FEMA Response to LOMR Questions sent by South Bethany on May 18, 2021

Figure – York County, Virginia, Coastal BFE Transitions

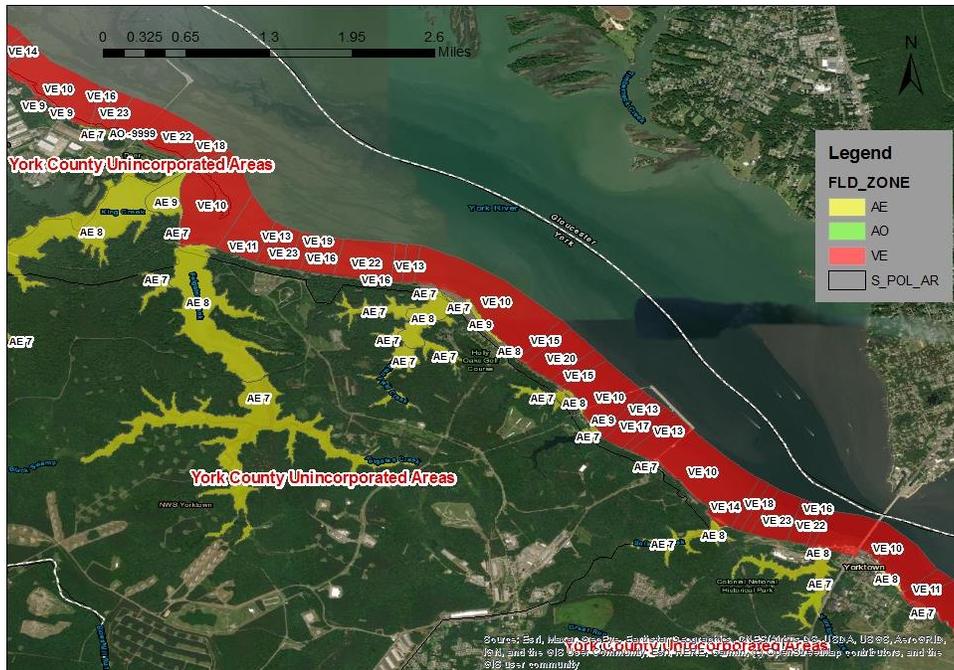
Why was new LiDAR used when it will most likely result in discrepancies between flood elevations between adjacent political subdivisions? Title 42 of U.S. Code § 4101b - National Flood Mapping Program directs to:

(b),(2), (B), (ii) *to eliminate, to the maximum extent possible, discrepancies in base flood elevations between adjacent political subdivisions.*

FEMA coastal FIRMs depict whole-foot BFEs and it is common for LOMRs to revise small areas, often just one property with different BFEs compared to adjacent unrevised properties. Further and due to mapping scale and varying shoreline characteristics, having continuous tie-ins on FIRMs along coastal floodplains, even on the order of 1 foot, is also not always feasible for coastal studies. Please see below an example from the current effective York County, VA, FIRM published in 2015. Due to the varying shoreline slopes, the BFEs of the VE zones along the shore have large changes in BFE up to 5 feet between neighboring zones. Please note there is not a 5-foot waterfall in between those zones, but rather a steep decline in wave heights of 5 feet across a relatively small area that cannot be reasonably depicted at whole-foot increments on the FIRM. This common mapping convention results in some of the differences in BFEs between the jurisdictional boundaries, but supporting modeling identifies the intermediate BFE zones that are not shown due to scaling.

Figure 23. Standard removal erosion geometry example for Transect 1610

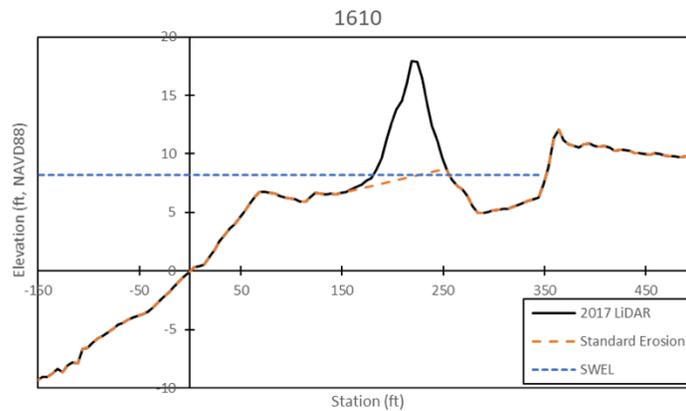
The Modified Erosion Methodology diverges widely from the Standard Erosion Methodology. As shown below, the Modified Erosion Methodology begins erosion at approximately -2.0 feet, rather than at the toe of the U.S. Army Corps of Engineers dune which is set at 7 feet under FEMA’s guidelines under the standard methodology. So, instead of starting erosion at the toe of a dune (at an elevation of more than seven feet), it starts erosion below sea level. The Modified Erosion Methodology removes an extraordinary amount of sand from the beach relative to the amount that would be removed under the Standard Erosion Methodology for the Atlantic Ocean and Gulf of Mexico coasts. This is clearly noted when you compare the inserted Figure 23 image below of transect 1610 taken from “Coastal Hazard Analysis Project Narrative: South Bethany, February 2021” with the one below that of the Modified Erosion Methodology.

A: The Modified Erosion Methodology is a variation of the Standard Erosion methodology and relies upon similar underlying geometric and volumetric principles as the FEMA Standard Erosion analysis. Such variations are deemed appropriate according to FEMA mapping guidance.

The Modified Erosion method differs from the Standard Erosion method only in its treatment of the dune removal profile. For the Modified Erosion method calculates dune removal with a profile that better matches the observed post-nourishment erosion geometry. The Modified Erosion profile preserves most characteristics of the standard “retreat” profile: it applies the same

dune toe elevation and erosion slopes as the Standard Erosion method and, like the Standard Erosion method, conserves sediment across the beach profile.

Illustration of Modified Erosion Methodology at South Bethany Transect 1610

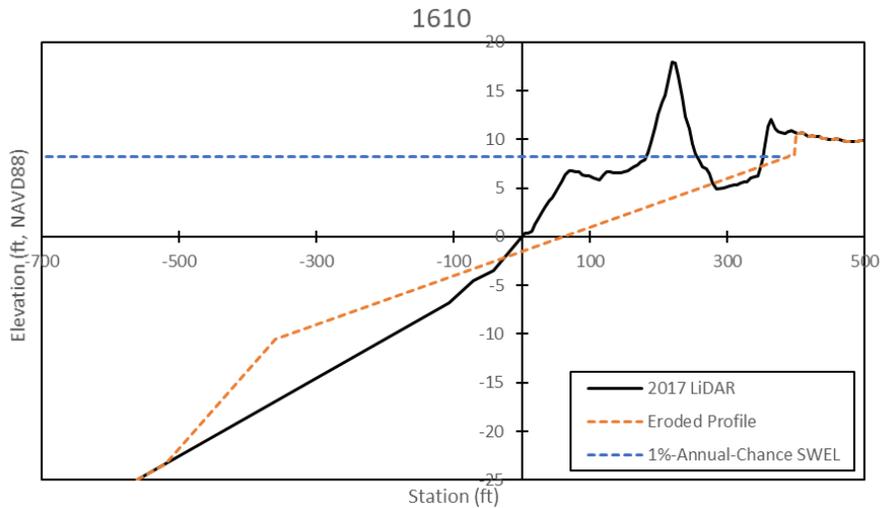
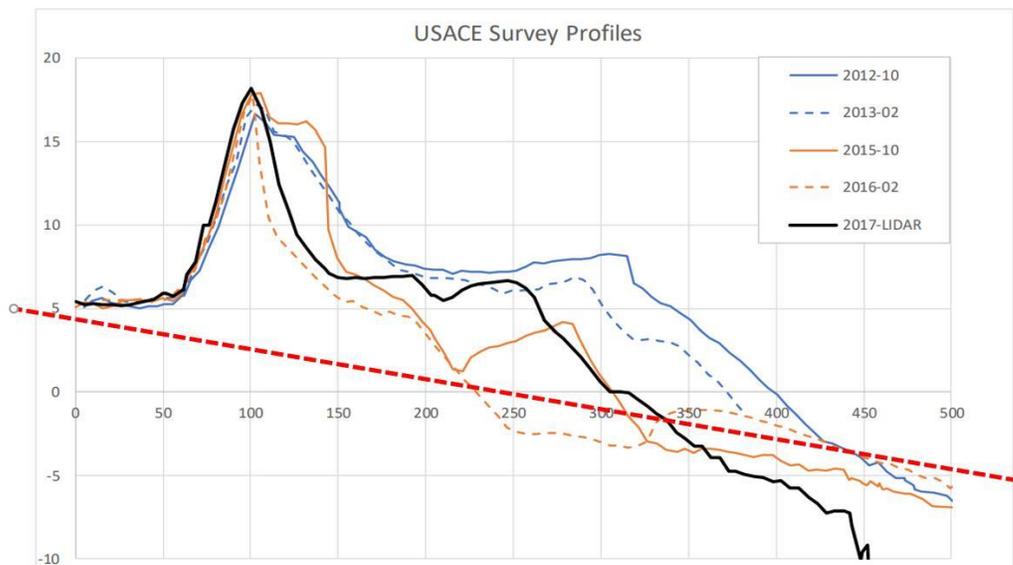
In addition, “Coastal Hazard Analysis Project Narrative: South Bethany, February 2021” Modified Erosion Method removes approximately 1,660 square feet from the Transect 1610 profile and eroded a constant-slope (40:1) surface from a point at elevation minus 2 feet on the 2017 profile for a landward distance of about 430 feet stopping at Ocean Drive. However, the assumed volume of erosion and configuration of the assumed eroded surface bear no relation to historical experience on this maintained profile, even considering the most extreme effects documented by the January 2016 storm.

The water level of the January 2016 winter storm roughly corresponded to a 10-percent-annual-chance flood level at the Town of South Bethany, the eroded profile of which certainly should not be considered as “most extreme effects.” FEMA Flood Insurance Studies (FISs) analyze 1-percent-annual-chance floods, which simulate more severe erosion scenarios than 10-percent-annual-chance storms. How the eroded areas from the recorded storms were used in the 2020 coastal analysis is explained in the Section 4.1.4 of the “Coastal Hazard Analysis Project Narrative: South Bethany, February 2021” report.

South Bethany FEMA Transect Layout

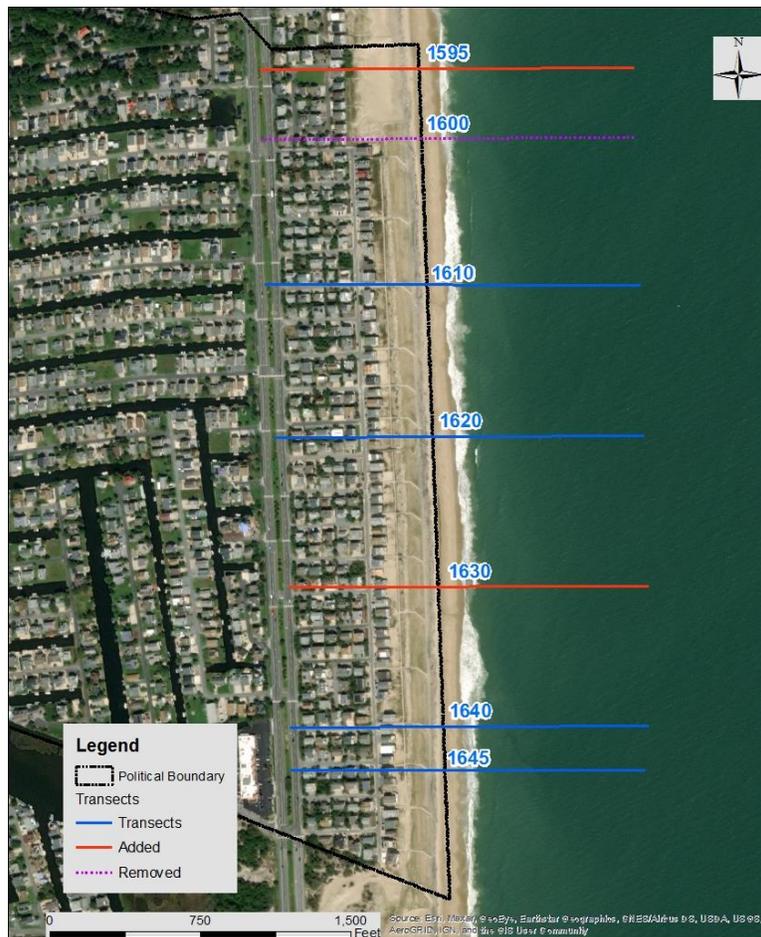
Also of note, Transect 1595 or 1600 are ignored in this analysis and should be considered, as well as treated differently based on the large expanse of beach and healthy condition of existing dunes (again see attachments D and E). The depth of this beach and the extreme size of the dunes shows that the topographic site plan indicating the height and width of dunes and beaches in this area are substantial.

Transect 1595 was not removed from the 2020 coastal analysis. The modeling results and mapping summary of Tr. 1595 are listed in Table 7 and Table 8 of the “Coastal Hazard Analysis Project Narrative: South Bethany, February 2021” report, respectively.

Tr. 1600 was removed from the 2020 coastal analysis as the large dune feature at this location is not representative of conditions to the north and south of this transect. Figure 2 in the “Coastal Hazard Analysis Project Narrative: South Bethany, February 2021” report illustrates this point.

Figure – Transect 39 from 1992 USACE Coastal Study

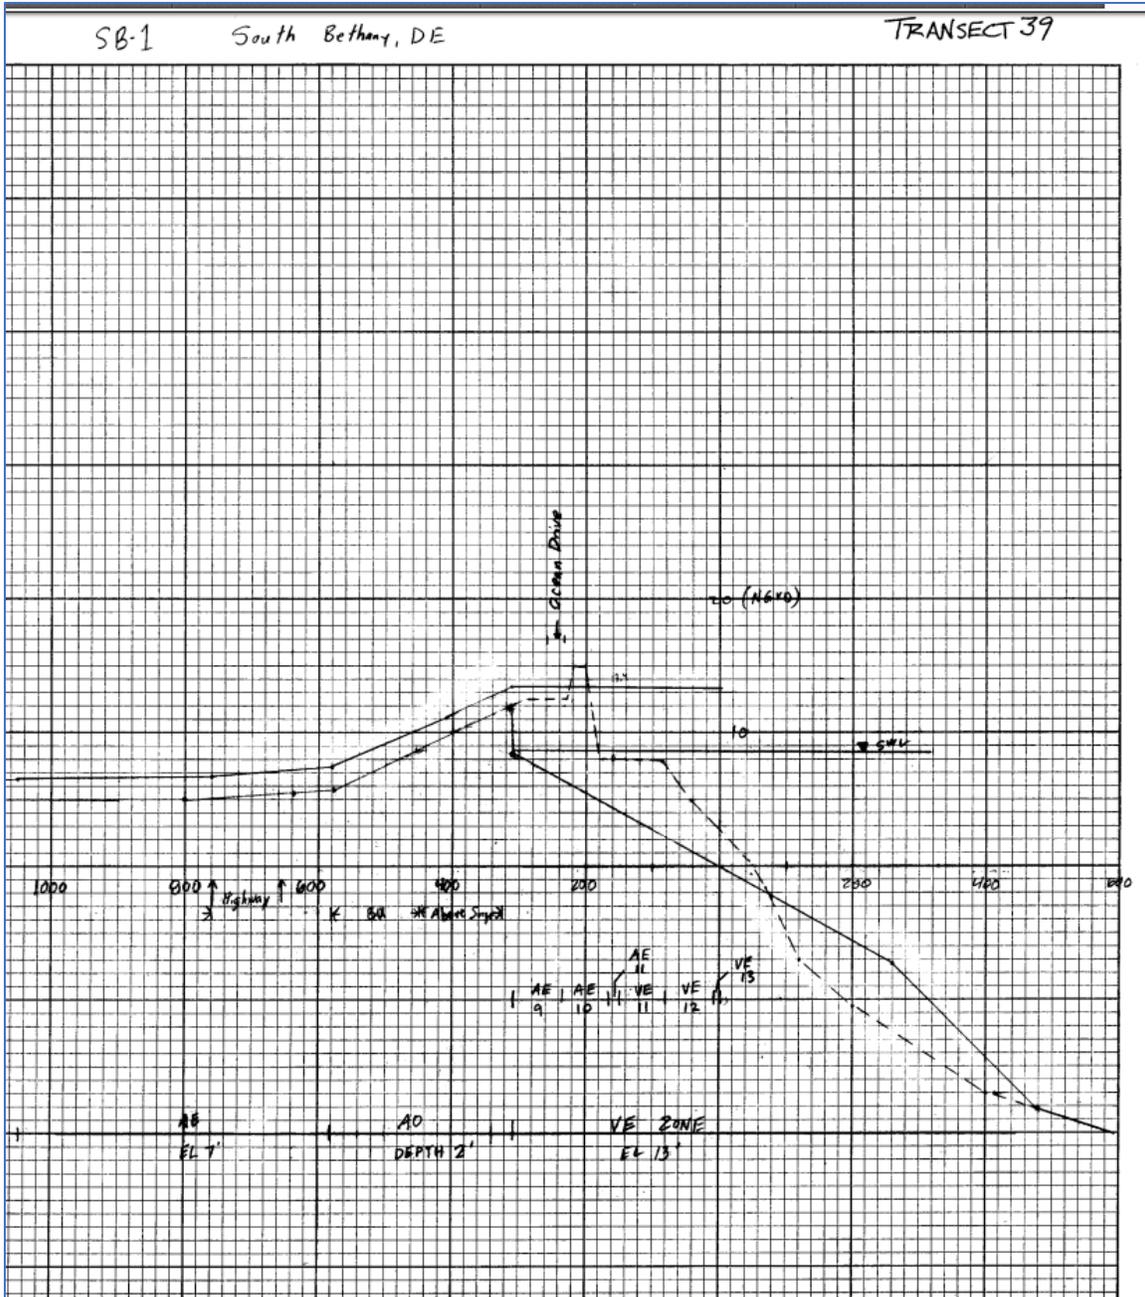
All of these examples previously provided are not relative to South Bethany Beach and may not share basic characteristics. There is no unusual site geometry and the historical erosion profiles are not vastly different in South Bethany than they are in neighboring communities. It is quite the contrary in South Bethany (in particular around Transects 1595 and 1600), as the beaches are extremely healthy with little additional sand provided on the beach near the waterline only in this area in the latest replenishment project this past winter.

The screenshot below was taken from the transect profile of Tr. 39, the only transect in Town of South Bethany from the 1992 study. The dune reservoir was less than 540 square feet (the 1-percent annual chance Still Water Elevation was 8.8 feet, the peak elevation of the dune was approximately 12.5 feet, and the length of the reservoir was

about 120 feet); specifically, the area of the reservoir was approximately 444 sq. ft $[(12.5' - 8.8') \times 120' = 444 \text{ sq. ft.}]$. As such, the dune would typically be removed for the analysis. The erosion profile, however, appears to be a “retreat” case with a steep eroded slope starting near the dune peak and eroded materials deposited offshore; therefore, it is considered a non-standard erosion.

The erosion profile is very similar to that of the 2020 coastal analysis except that the erosion of the 2020 coastal analysis stops at seaward of Ocean Drive, considering the protection from the revetment that was completed in 1999. For the 2014 revised preliminary FIRM, the study team considered Ocean Drive as eroded as the team was not aware of the existence of the revetment along seaward of Ocean Drive when the analysis was conducted.
